PLANNING, ZONING, & BUILDING DEPARTMENT  
PZ&B Staff Memorandum: Landmarks Preservation Commission

SUBJECT: COA-23-040 (ZON-23-109) 134 EL VEDADO ROAD(COMBO)

MEETING: NOVEMBER 17, 2023, LPC  
DECEMBER 13, 2023, TC

The applicant has submitted plans, entitled "Alterations to 134 El Vedado Road", as prepared by Asbacher **Architecture, Inc.** dated October 13, 2023.

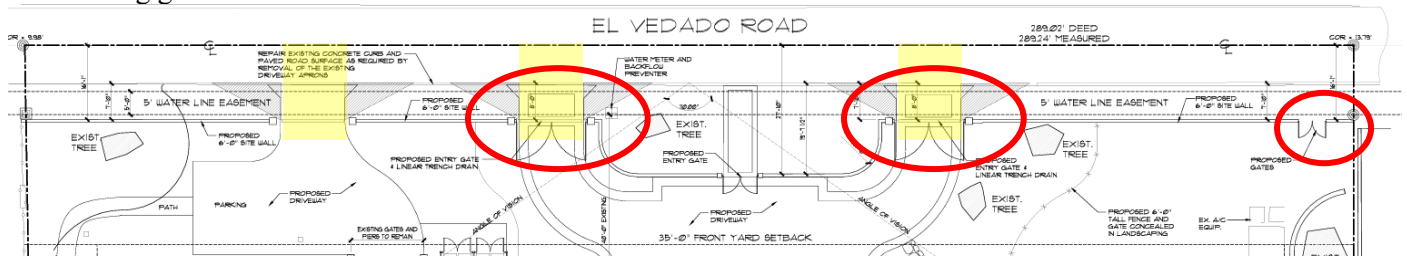
documentation for reference to restore areas such as the opening of the sunroom. However, the opaque gate design, location and height could be restudied to let the architecture on site shine.

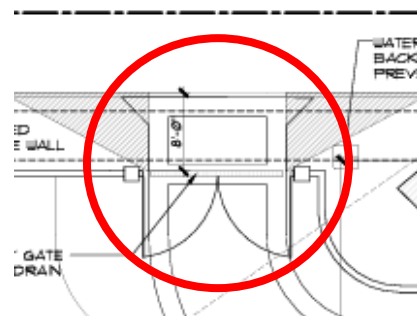
Additionally, the applicant is proposing a new 6'-0" high site wall along the front property line facing El Vedado Way, setback 8'-0" from the edge of the curb. Where two vehicular curb cuts are currently existing, the applicant is proposing three. A new dual access vehicular entrance sequence shall be differentiated from a secondary means of vehicular access and shall be delineated with two swing gates.

The new gates are proposed solid wood, in a diagonal Chippendale style. The site wall, front landscaping and solid panel gates and pedestrian gate will further obscure the landmarked property from view.

There is an existing gate setback considerably from the roadway currently. And this portion of the

proposal will alter the view that is currently offered.

El Vedado Way is a narrow (20'-0") wide from curbs edges) roadway. There are some properties with dense landscaping along the front property line, and also those with property walls. In fact, directly across the street is a property at 135 El Vedado Rd that also has vehicular gates, albeit in a transparent metalwork design that affords views into the site. Otherwise, vehicle gates seem more common on the western block portion of El Vedado Road, across South County Road, rather than along this eastern 100 block towards the ocean. There is also a variance associated with the proposal, to reduce the required vehicular backup driveway space to install a driveway gate with an 8'-4" setback from the edge of pavement in lieu of the 18'-0" minimum required which does not appear to be consistent with the streetscape.

Staff would recommend further study on the wall placement in order to ensure the survivability of all three of these tree resources. Additionally, a more transparent fencing and gate should be studied as well as lowering the site wall to a height more similar properties to those along El Vedado.
